HEREFORD PROPOSED TRANSPORT HUB

Formal Representation and scheme development

Planning Application no **233009**

From: Hereford Civic Society

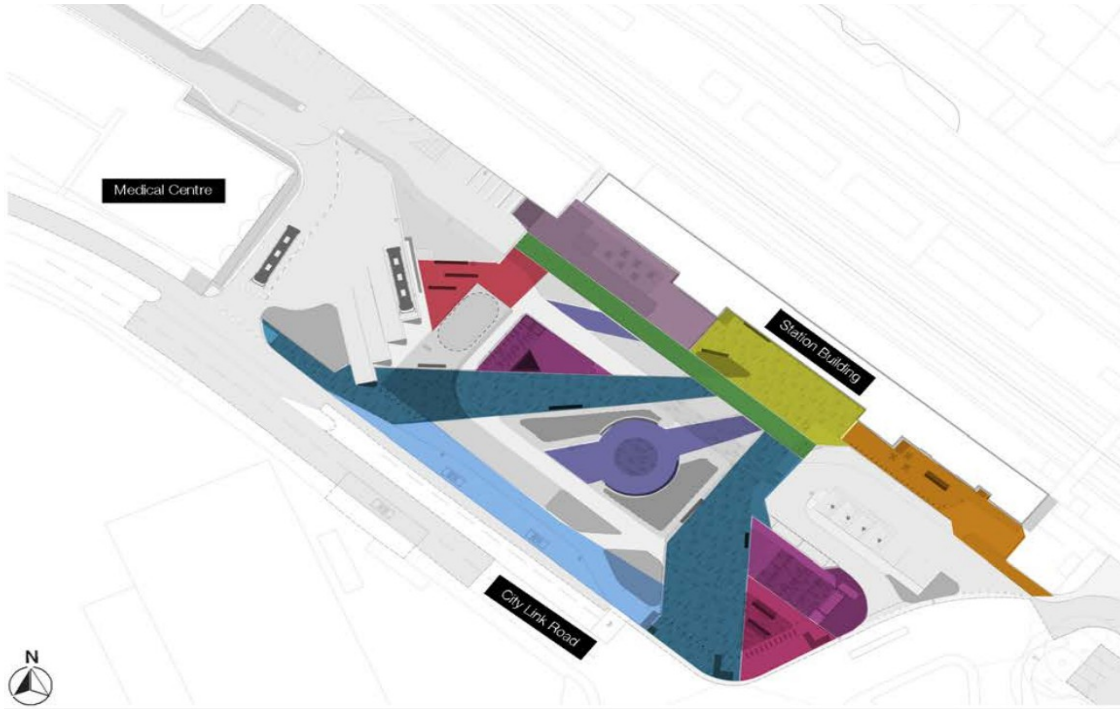
19. **Station heritage building.** Impact on listed building of glazed canopy and more particularly of enlarged entry to booking hall (shown in slide 13 of 24 Jan 2024 presentation, not in the applicant's drawings). A carefully considered design response for the supporting ironwork for this canopy would be required.

1.4.1 Ugly and unsympathetic plain glazed entrance to listed station proposed by Weston Williamson (Source: *presentation* slide 13) would not be supported in heritage terms. Fussy scheme using high carbon man-made paving materials not considered appropriate for situation or net zero ambition – use local and natural materials (eg Pennant sandstone) to simplified scheme.

1.4.2 Incongruous, cheap-looking, alien and poorly articulated structures shown in this visualisation (source: *Heritage & Townscape Assessment*, Sept 2023, p.34)

3.1 Drive-through stands.

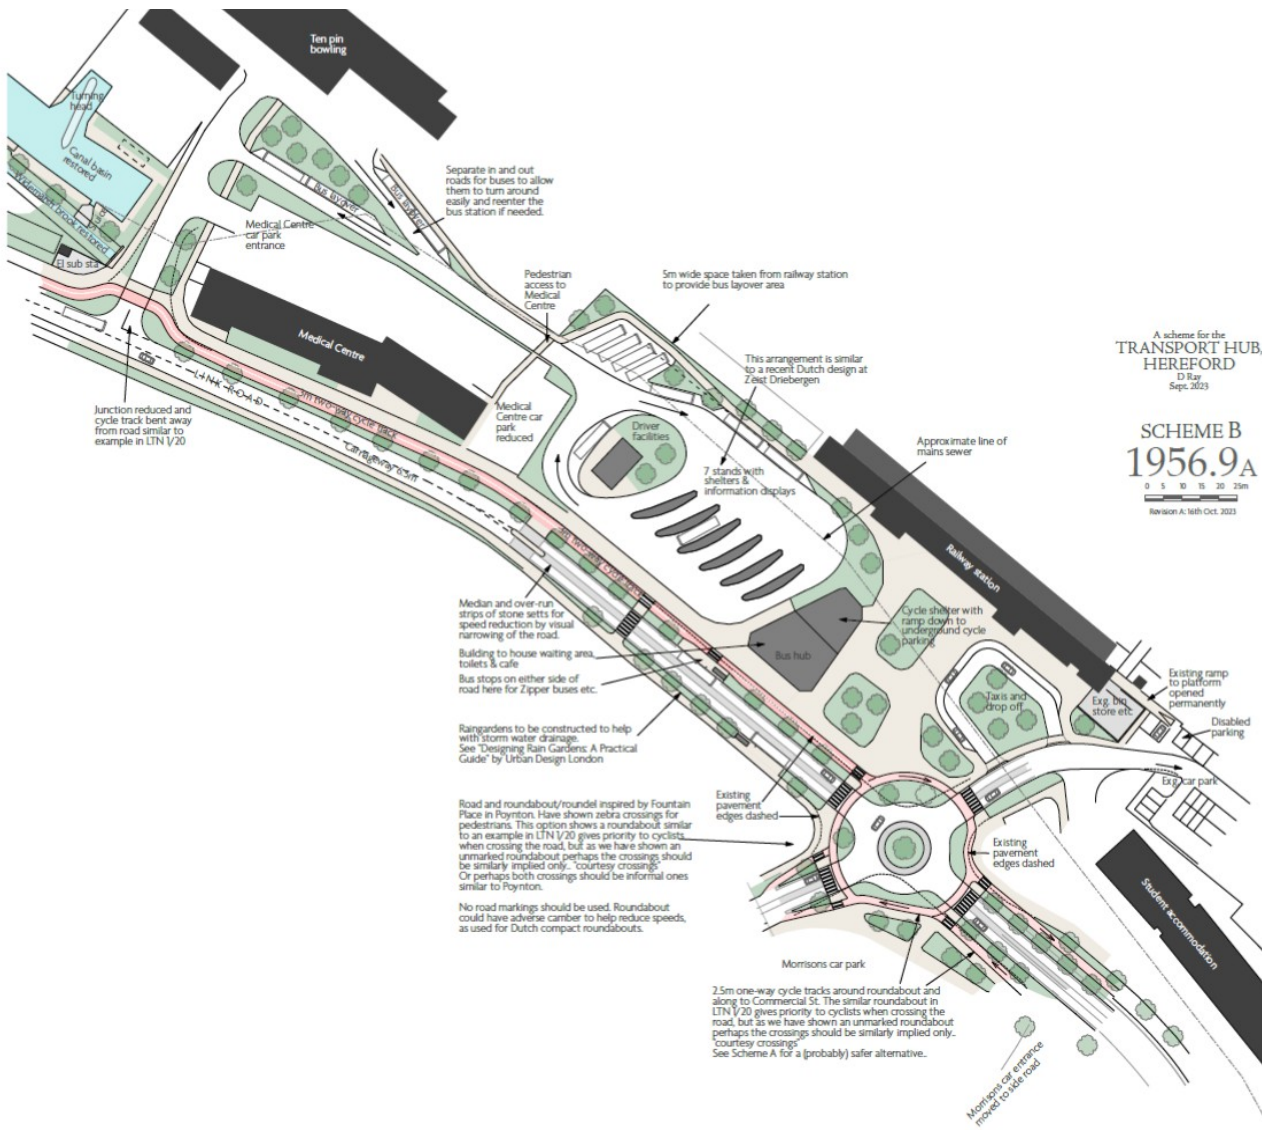
This solution delivers greater capacity, minimises bus reversing manoeuvres, avoids the need to create an additional side road junction to the City Link Road (CLR) and allows for the creation of a pedestrian piazza. It also allows for restoration of the canal and reformation of a canal basin by bringing the layover closer to the main site and improved pedestrian accessibility to the Medical Centre. In common with all the improved schemes in these pages, it designs for greatly improved vehicle and active travel infrastructure on the CLR with better connectivity between the Transport Hub and the City as a whole. There would be bus-stop lay-bys both sides of the CLR.

It does, however, require partnership-working and co-operation with the Medical Centre and with Network Rail/ Transport for Wales to deliver a result better for all parties and better to support modal shift to more sustainable forms of transport as Local Plan Policy MT1 requires.

3.2 Drive-through saw-tooth, entry and exit to NW

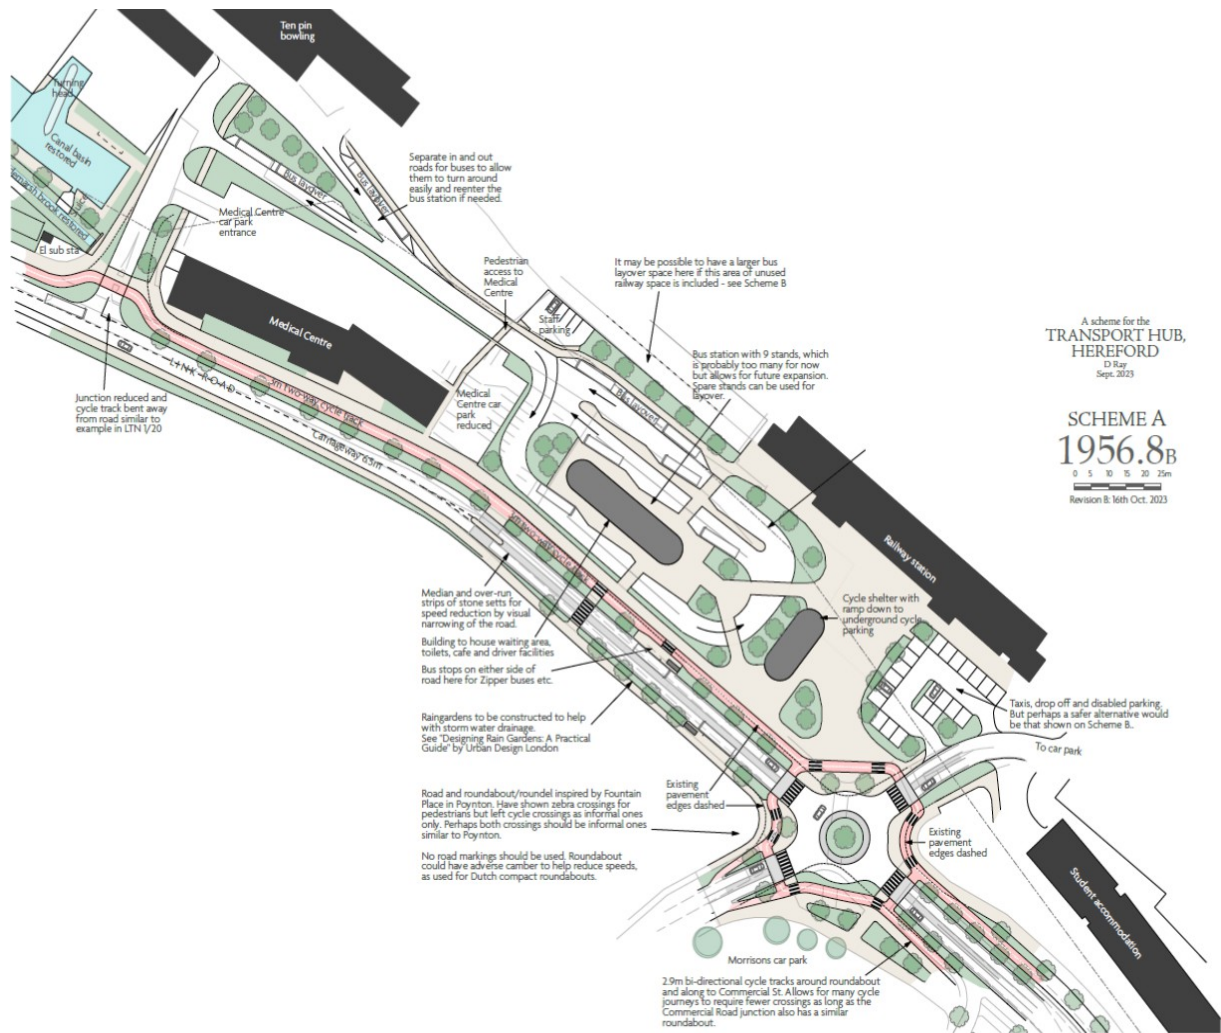
This solution also delivers greater capacity, minimises bus reversing manoeuvres, avoids the need to create an additional side road junction to the CLR and allows for the creation of a pedestrian piazza albeit smaller in size. It also allows for restoration of the canal and reformation of a canal basin by bringing the layover closer to the main site and improved pedestrian accessibility to the Medical Centre. There would be bus-stop lay-bys both sides of the CLR.

In common with all the improved schemes in these pages, it designs for greatly improved vehicle and active travel infrastructure on the CLR with better connectivity between the Transport Hub and the City as a whole.

It does, however, require partnership-working and co-operation with the Medical Centre and with Network Rail/ Transport for Wales to deliver a result better for all parties and better to support modal shift to more sustainable forms of transport as Local Plan Policy MT1 requires.

3.3 Drive-through saw-tooth, enter from NW, exit to SE, version 1

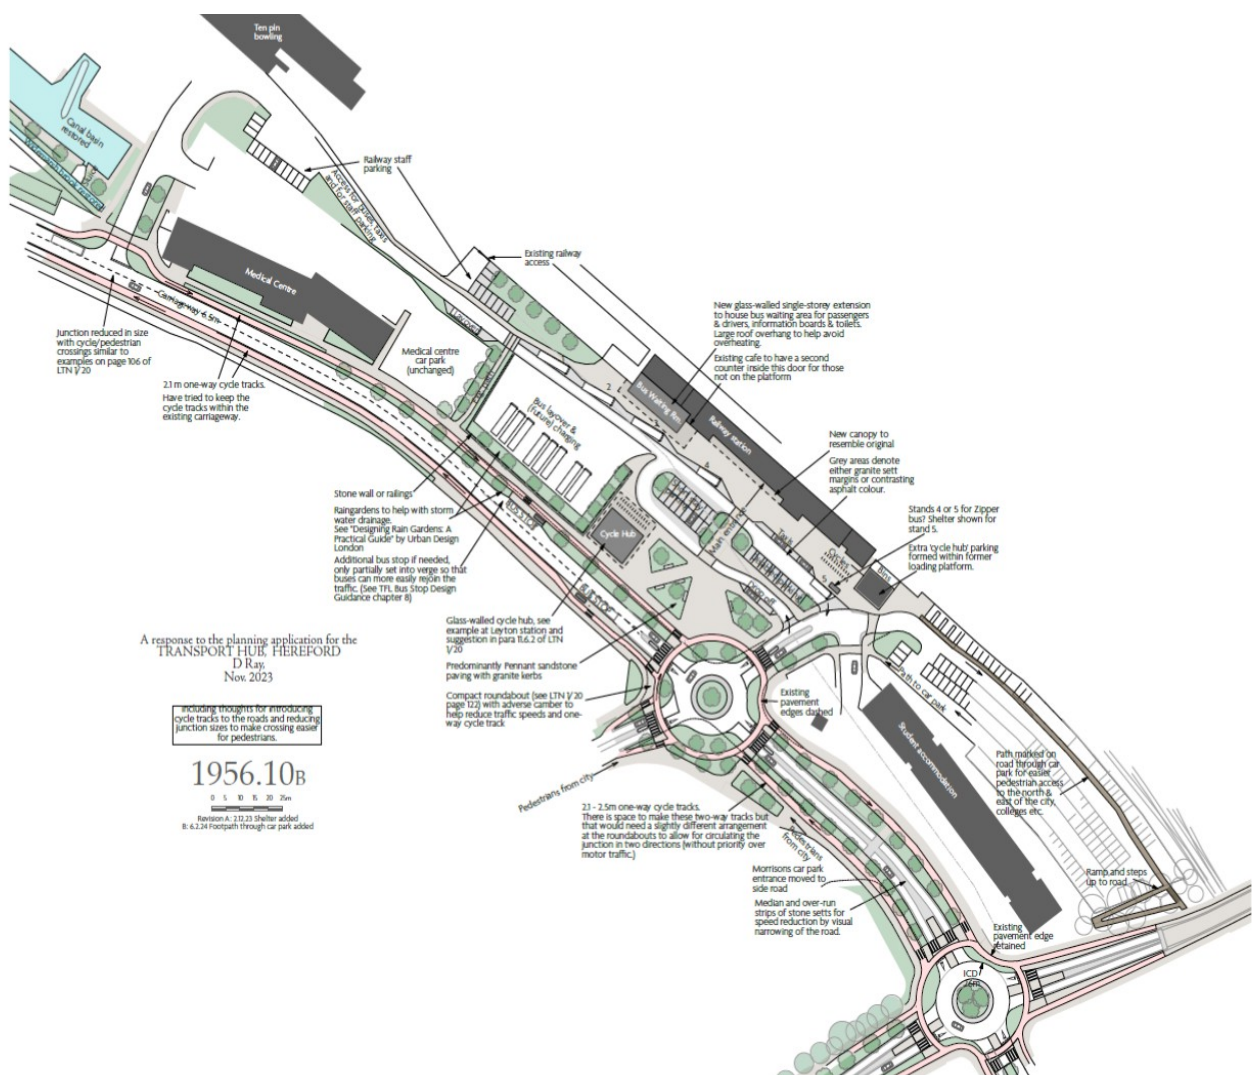
This solution avoids the need to create an additional side road junction to the CLR and allows for the creation of a pedestrian piazza albeit much smaller in size. It also allows for restoration of the canal and reformation of a canal basin by bringing the layover to the main site and improved pedestrian accessibility to the Medical Centre. Allowance is made to facilitate the electric 'Zipper' bus to stop closer to the Station rather than on the CLR, where there would also be bus-stop lay-bys both sides.

It assumes that partnership-working and co-operation with the Medical Centre and with Network Rail/ Transport for Wales have not been successful with the result that the piazza is very small and there is conflict between pedestrians and vehicles immediately outside the front of the station as now. A direct stepped/ ramped path between the Hub site and the bottom of Aylestone Hill has been provided as an alternative to the present narrow pavement round by the road

In common with all the improved schemes in these pages, it designs for greatly improved vehicle and active travel infrastructure on the CLR with better connectivity between the Transport Hub and the City as a whole. This supports modal shift to more sustainable forms of transport as Local Plan Policy MT1 requires.

3.4 Drive-through saw-tooth, enter from NW, exit to SE, version 2

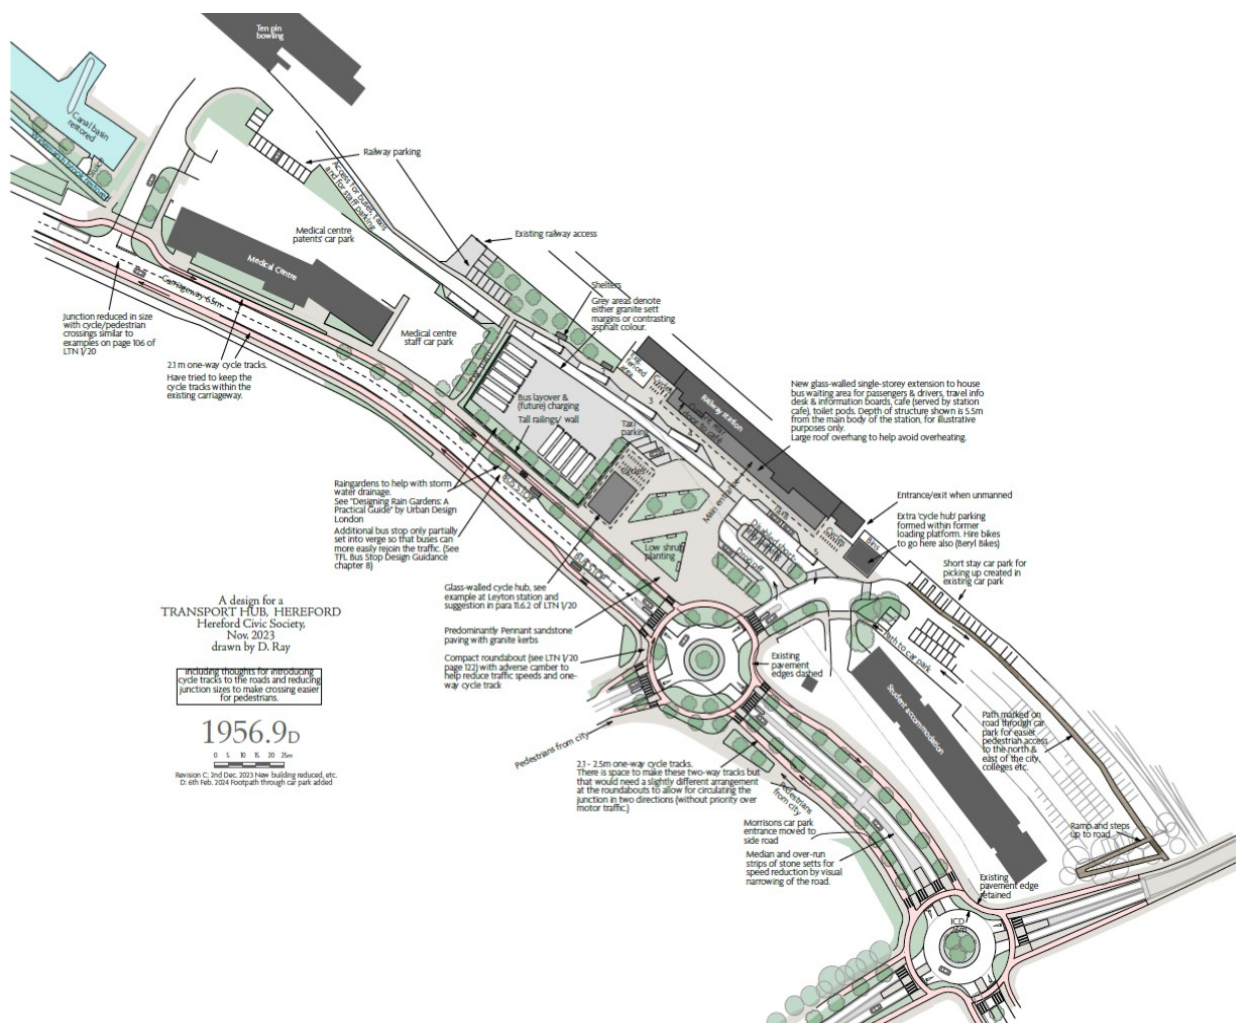
This solution avoids the need to create an additional side road junction to the CLR and allows for the creation of a pedestrian piazza albeit of modest size. It also allows for restoration of the canal and reformation of a canal basin by bringing the layover to the main site and improved pedestrian accessibility to the Medical Centre. Allowance is made to facilitate the electric 'Zipper' bus to stop closer to the Station rather than on the CLR, where there would also be bus-stop lay-bys both sides. A glass-fronted covered flexible space shelter in front of the Station is proposed, but it is accepted this would have to be very carefully designed to complement and enhance the listed building.

It assumes that partnership-working and co-operation with the Medical Centre and with Network Rail/ Transport for Wales have not been successful but with a smaller drop off/taxi facility the piazza remains adequate. There is less conflict between pedestrians and vehicles immediately outside the front of the station than in version 1. A direct stepped/ ramped path between the Hub site and the bottom of Aylestone Hill has been provided as an alternative to the present narrow pavement round by the road

In common with all the improved schemes in these pages, it designs for greatly improved vehicle and active travel infrastructure on the CLR with better connectivity between the Transport Hub and the City as a whole. This supports modal shift to more sustainable forms of transport as Local Plan Policy MT1 requires.

3.5 Drive-in-Reverse Out (DIRO), enter from NW, exit new side road to SW

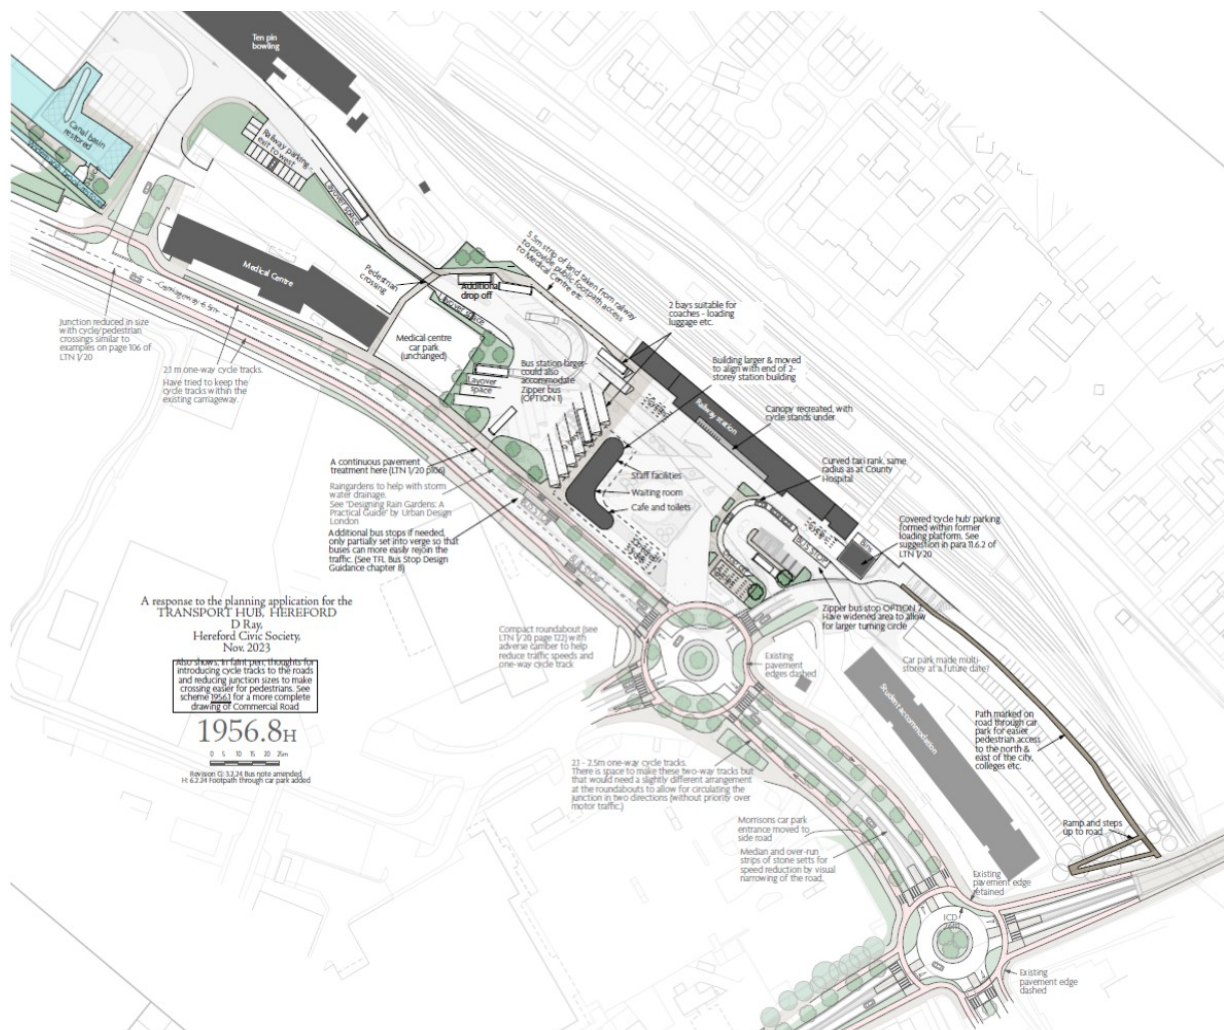
It assumes that partnership-working and co-operation with Network Rail/ Transport for Wales has been successful and that their staff parking has been relocated as shown but not successful with the Medical Centre with the result much of the usable space is given over to private HMG car parking rather than public benefit.

Even so, and in spite of the conflict with an additional side road, it improves pedestrian accessibility to the Medical Centre and beyond over the designs submitted for planning. A direct stepped/ ramped path between the Hub site and the bottom of Aylestone Hill has been provided as an alternative to the present narrow pavement round by the road

In common with all the improved schemes in these pages, it designs for greatly improved vehicle and active travel infrastructure on the CLR with better connectivity between the Transport Hub and the City as a whole. This supports modal shift to more sustainable forms of transport as Local Plan Policy MT1 requires.
